### Proposed Revisions to a Standard Plans Index

Index Number: 711-003

Index Title: Interchange Markings

SINGLE LANE RAMPS - ENTRANCE TERMINALS

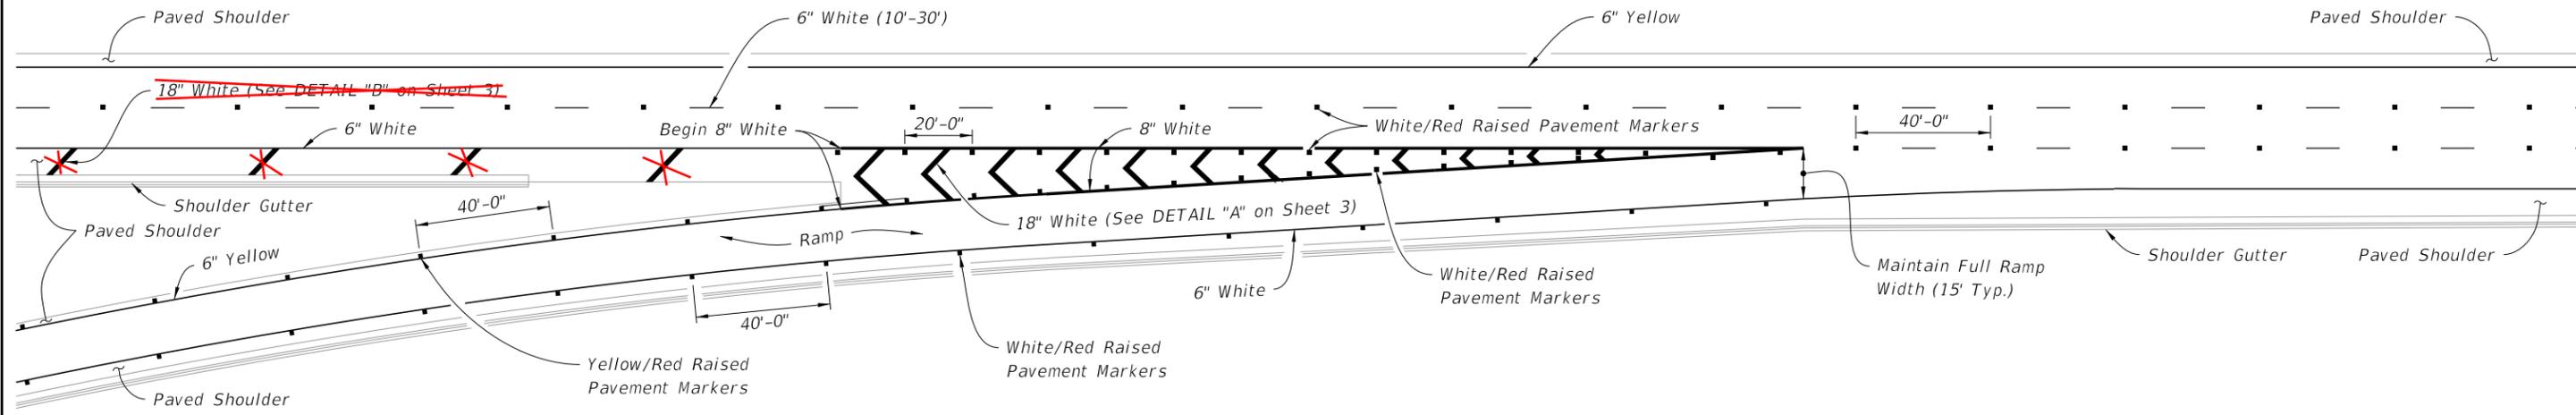
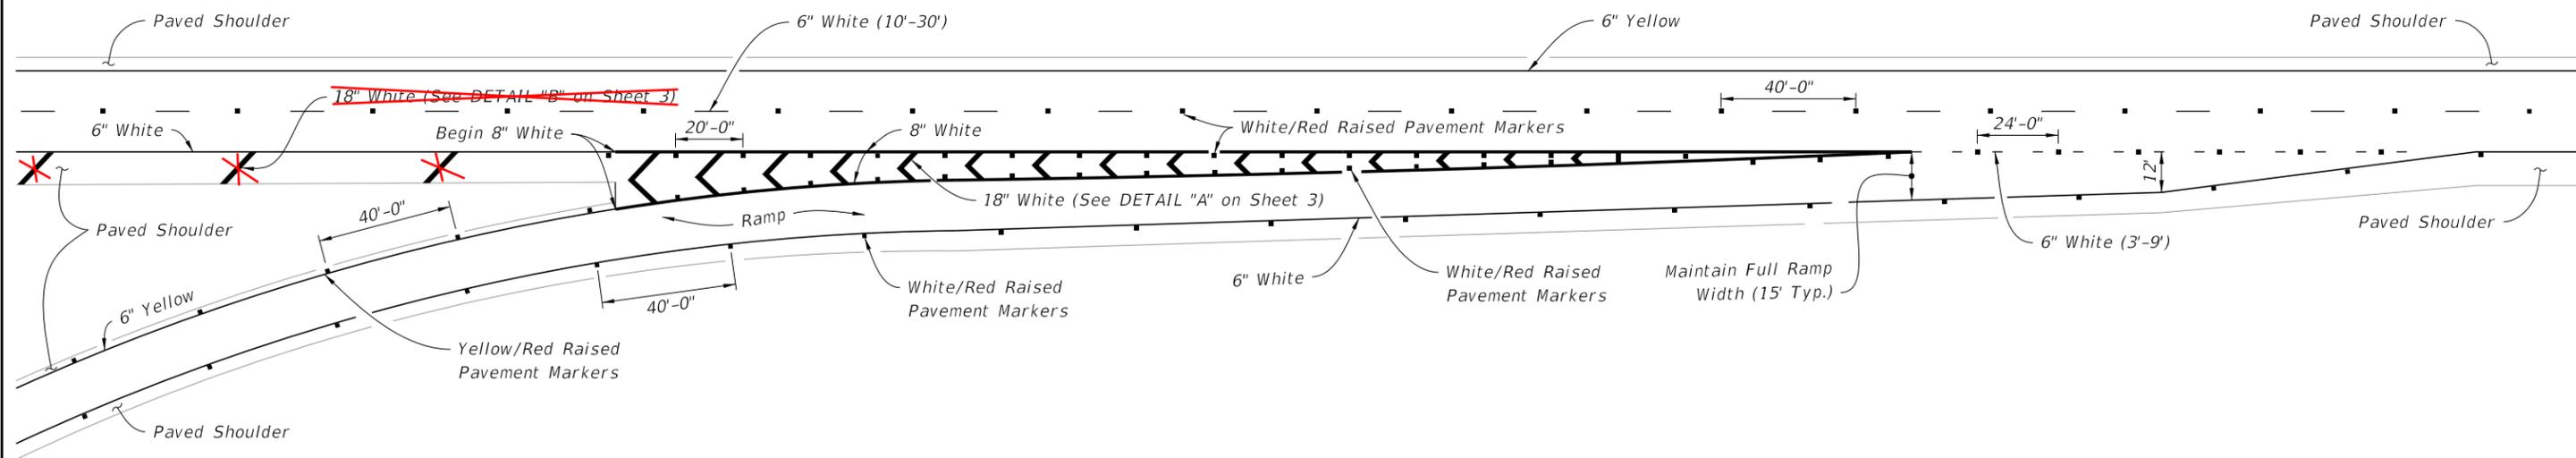
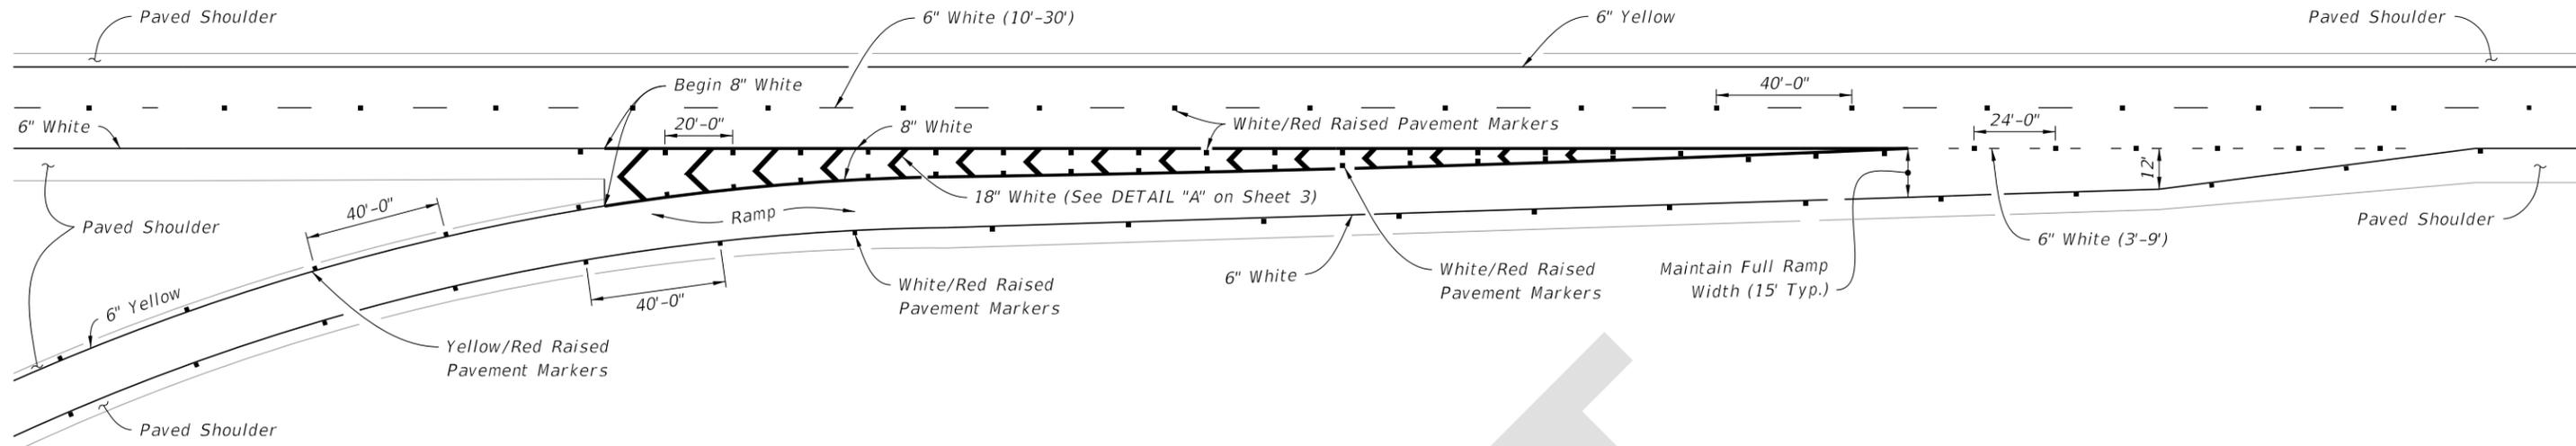
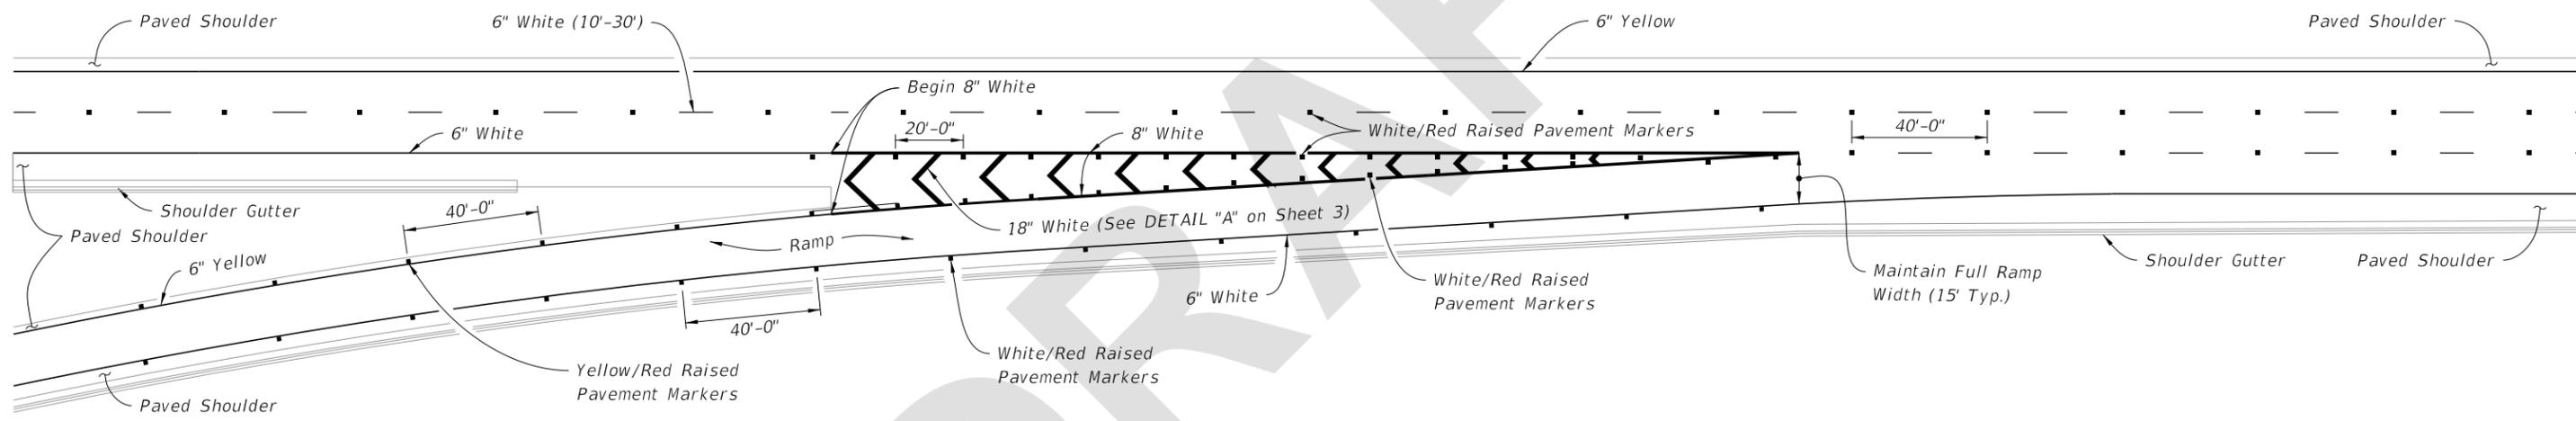
Sheet 1: Deleted the 18" white hash marks

18" diagonal markings on entrance ramps were deleted because they were not required by the AASHTO Greenbook

TYPICAL PAVEMENT MARKINGS AT ENTRANCE RAMPS

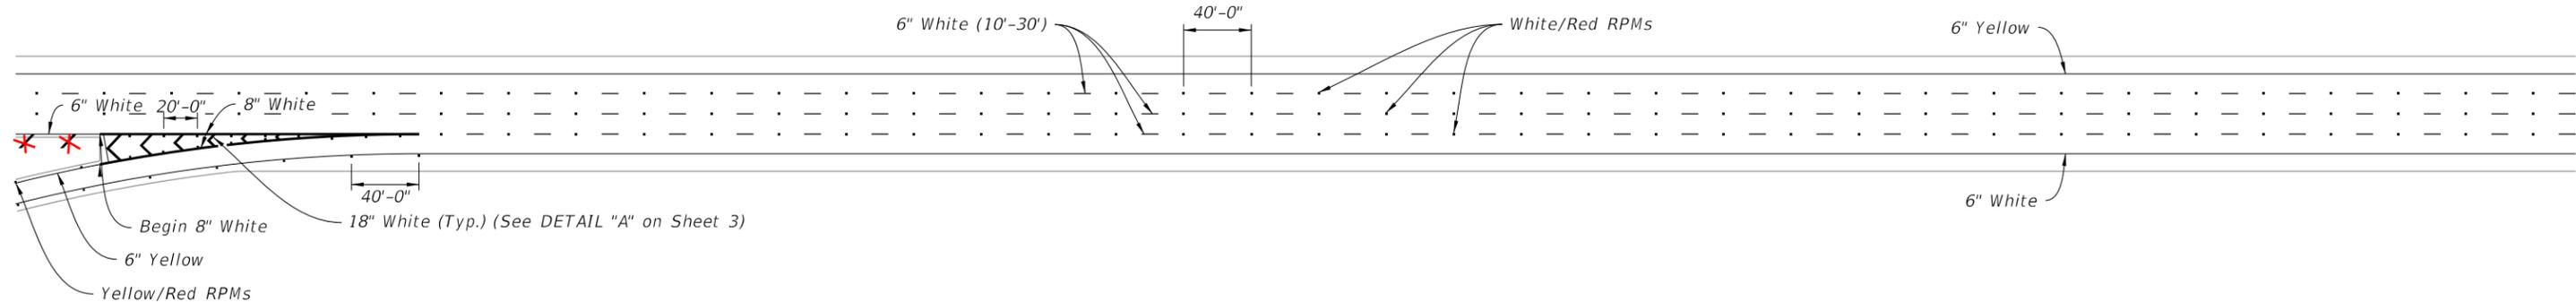
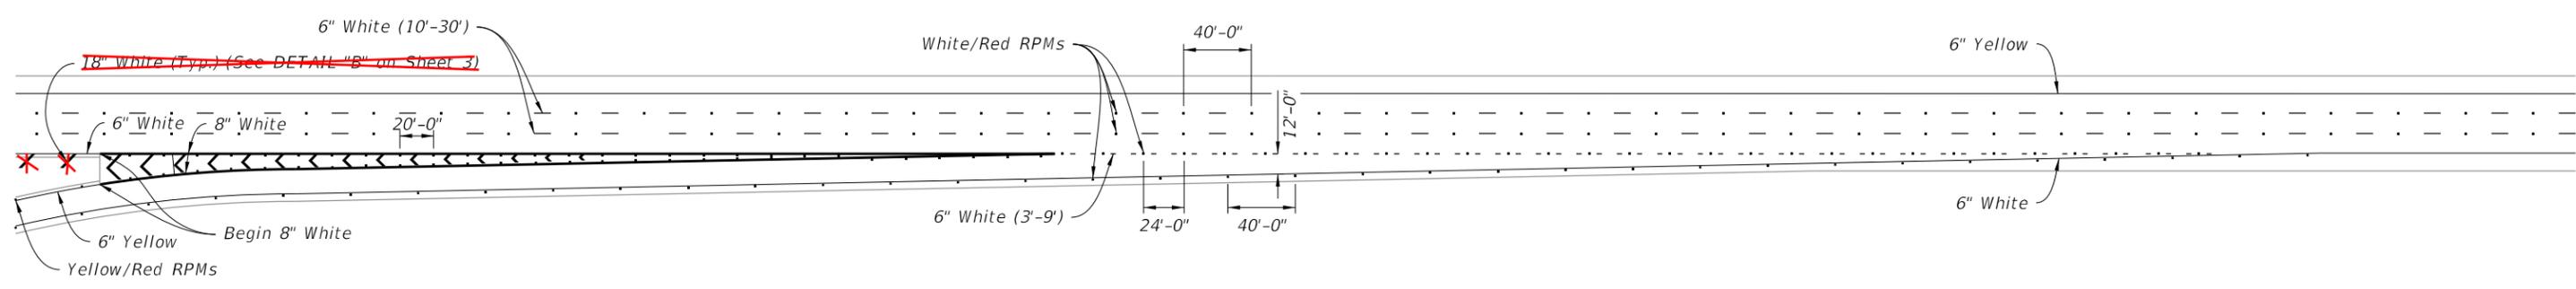
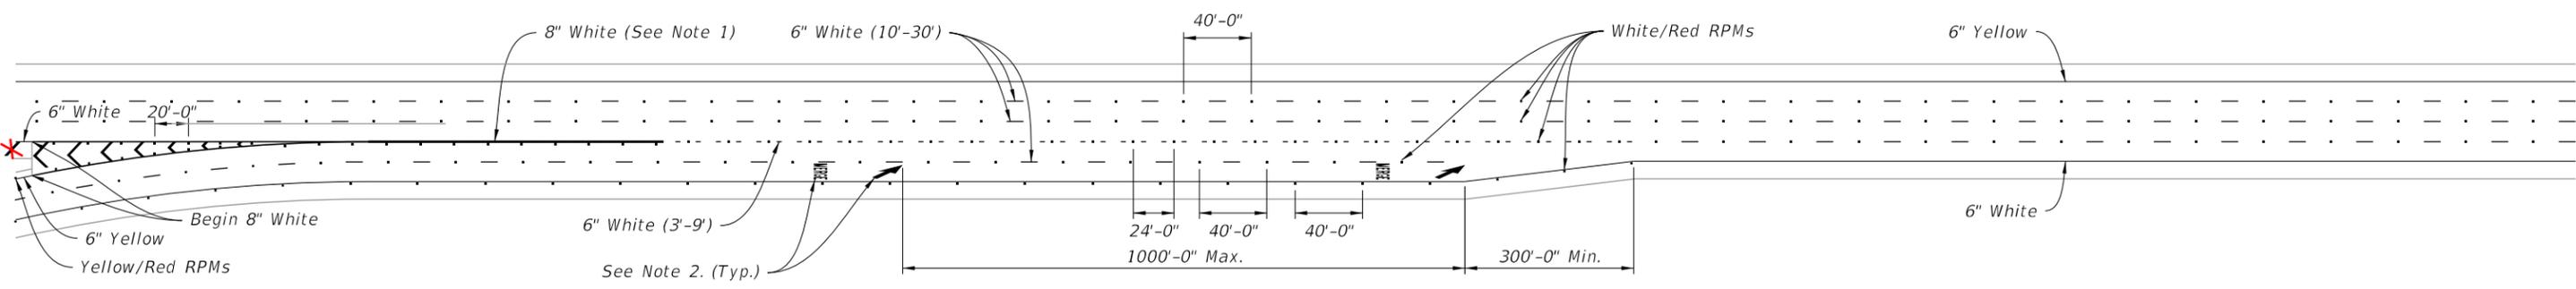
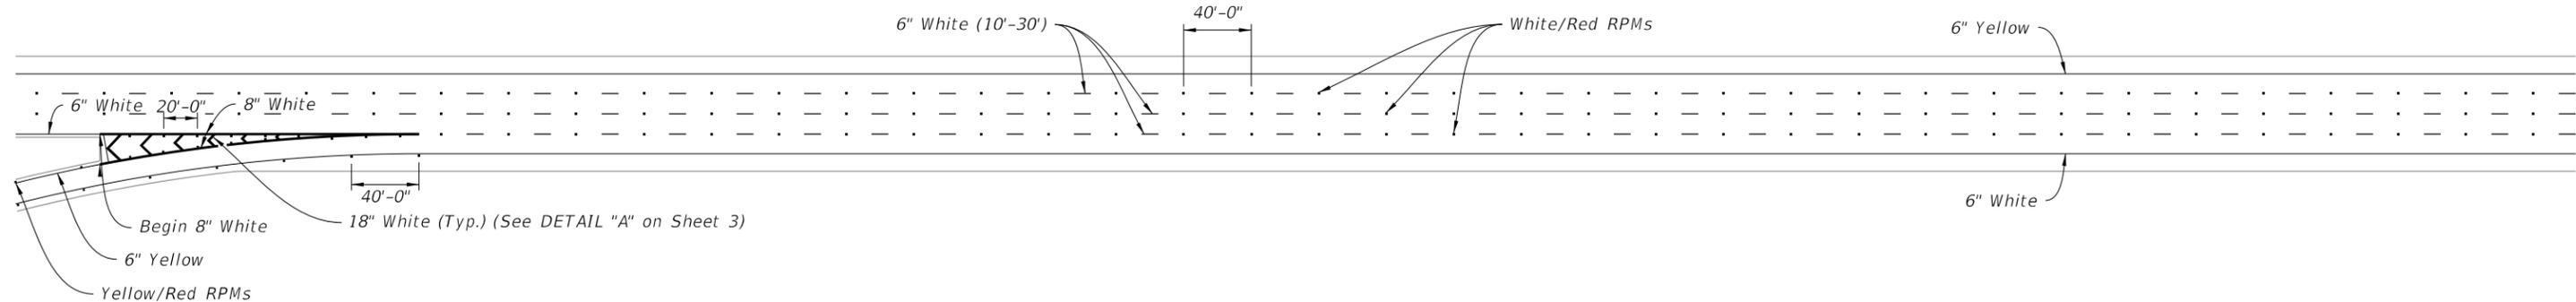
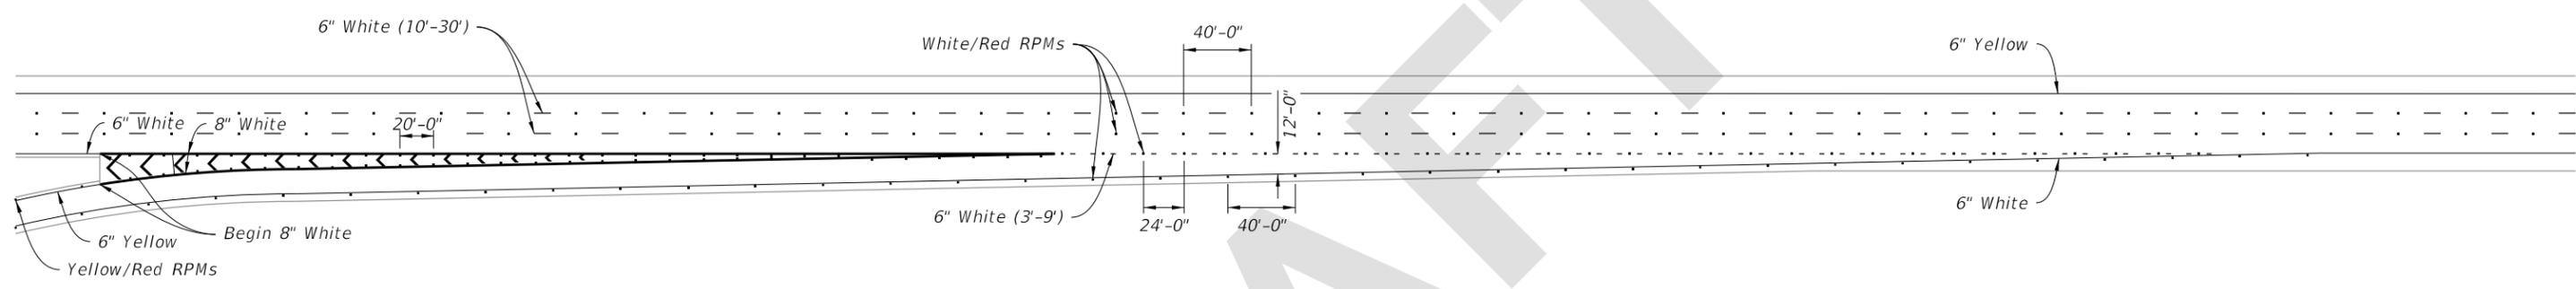
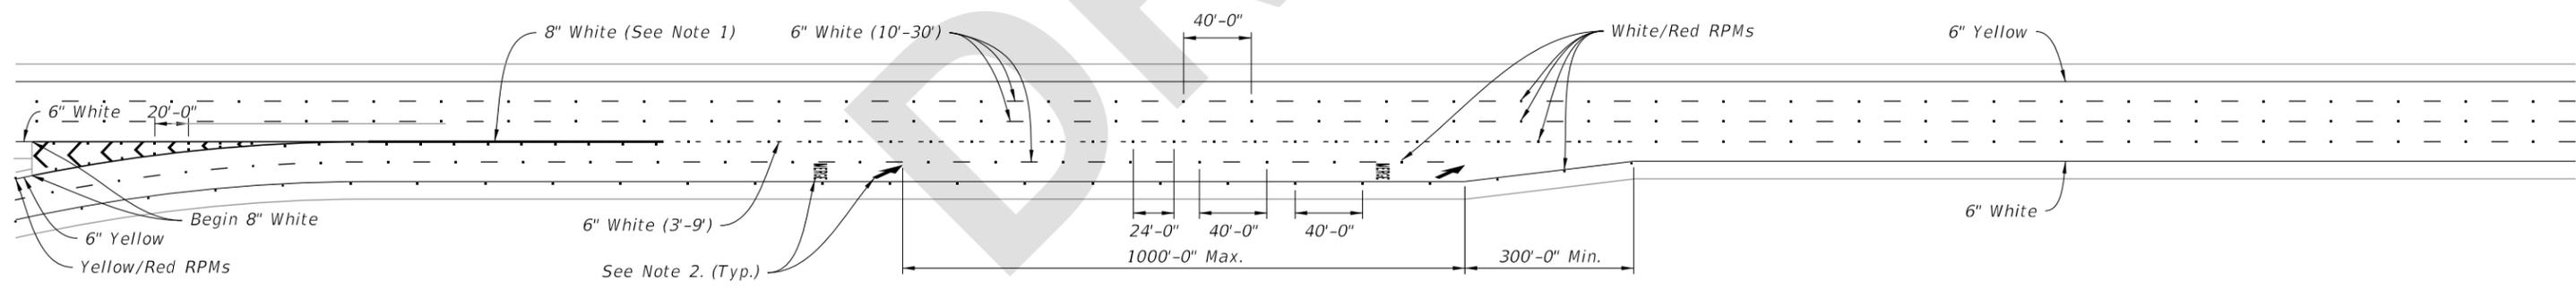
Sheet 2: Deleted the 18" white hash marks
